Date 5/4/00 Project Name: Motel 6

Subdivision Motel 6 - Dev. in H.O.

Date 8/10/76 Item # 52-76

Petitioner Motel 6 Inc.

GRADING PLAN SCALE 1" = 30'

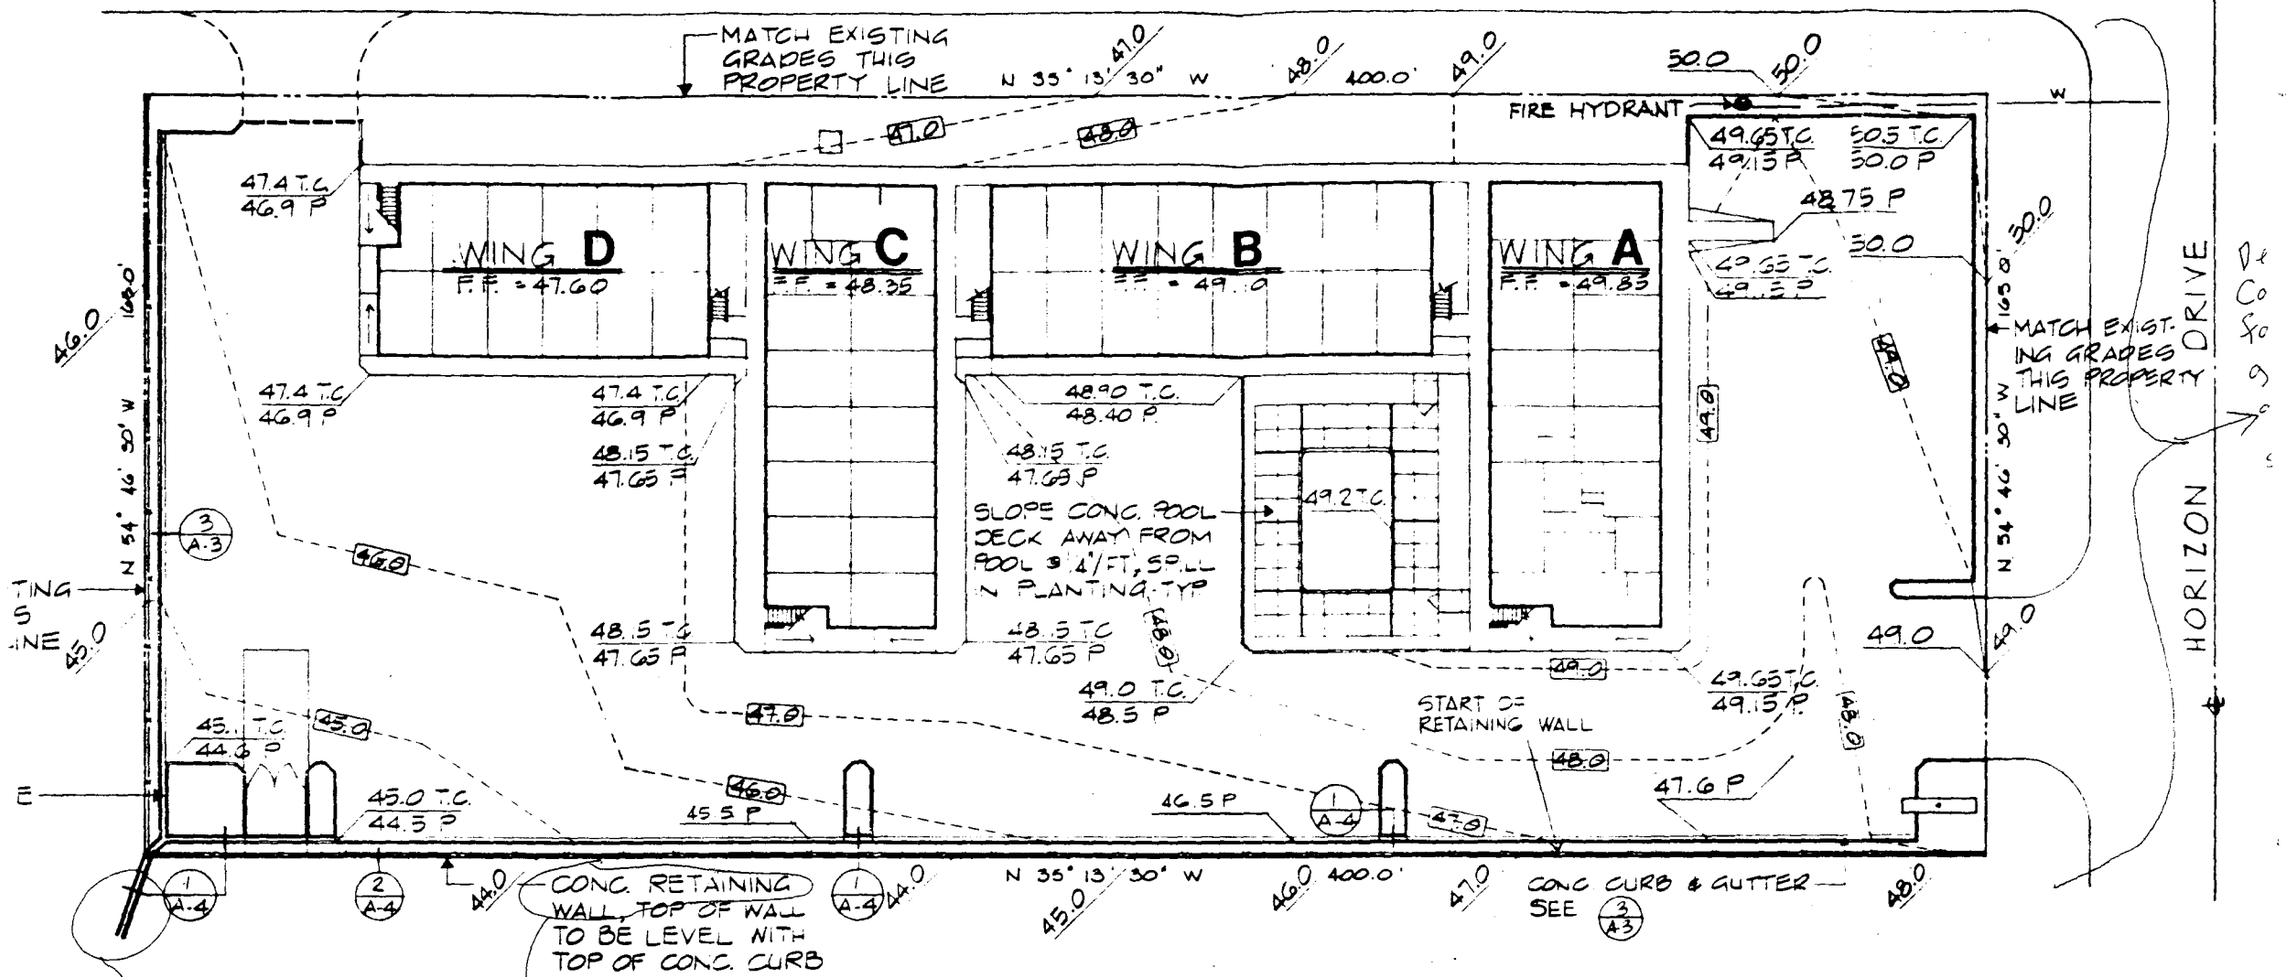
site runoff apparently
out through this flume.
does the flume outlet
Does whatever it outlets
ve the physical capacity for anticipated flows?
have the legal right to dump the

where is this wall in relation to the property line?
